Access Compliance Report

Public Rights-of-Way

(Curb Ramps)

Intersection ID: 27432	Main Street: BALLANTYNE COMMONS PY	Cross Street: DURANT BV	Location:	SE
ADA ID: 0B8611A1373C	Ramp Type: Perp	Initial Pass/Fail: Fail	Overall Compliance: No	Severity Score: 22.5
Codes/Mitigation Info/Possible Solution			Field Measurements/Component Compliance

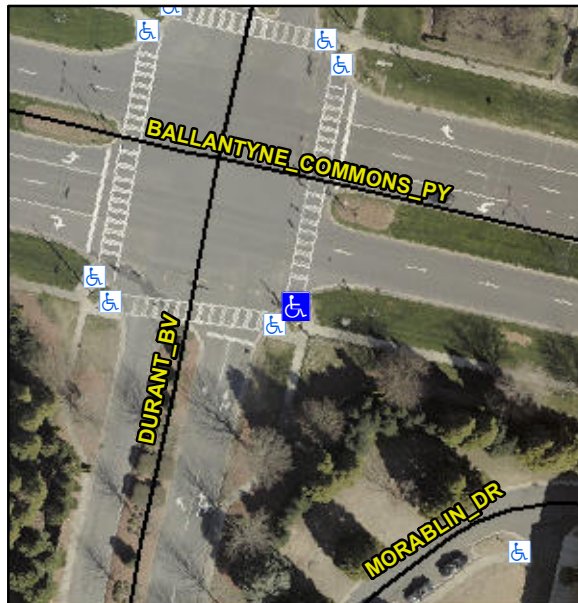
Not Found, R304.5.1

Compliance	Description	Data	Compliance	Description	Data
N/A	Ramp Length (in)	207.0	Yes	Ramp Slope (%)	11.5
No	Ramp Width (in)	44.0	Yes	Ramp XSlope (%)	4.1
N/A	Flare Type LT	N/A	N/A	Flare Type RT	N/A
N/A	Flare Slope LT (%)	N/A	N/A	Flare Slope RT (%)	N/A
N/A	Flare Traversable LT?	N/A	N/A	Flare Traversable RT?	N/A
N/A	Landing Length (in)	N/A	N/A	DWS Provided?	N/A
N/A	Landing Width (in)	N/A	N/A	DWS Contrast?	N/A
N/A	Landing Slope (%)	N/A	N/A	DWS Length (in)	N/A
N/A	Landing X Slope (%)	N/A	N/A	DWS Full Width?	N/A
N/A	Landing Curb? (Y/N)	N/A	N/A	DWS Offset (in)	N/A
N/A	Shared Landing?	N/A			
N/A	Gutter Ponding?	N/A	N/A	Gutter Slope (%)	N/A
N/A	Gutter Lip Ht (in)	N/A	N/A	Gutter X Slope (%)	N/A
N/A	Painted X Walk1?	Yes	N/A	Painted X Walk2?	N/A
	X Walk 1 Direction	To NE		X Walk 2 Direction	N/A
N/A	X Walk 1 Width (in)	117.0	N/A	X Walk 2 Width (in)	N/A
	X Walk 1 Slope (%)	0.2		X Walk 2 Slope (%)	N/A
	X Walk 1 X Slope (%)	4.7		X Walk 2 X Slope (%)	N/A

Remove & Replace Entire Ramp.
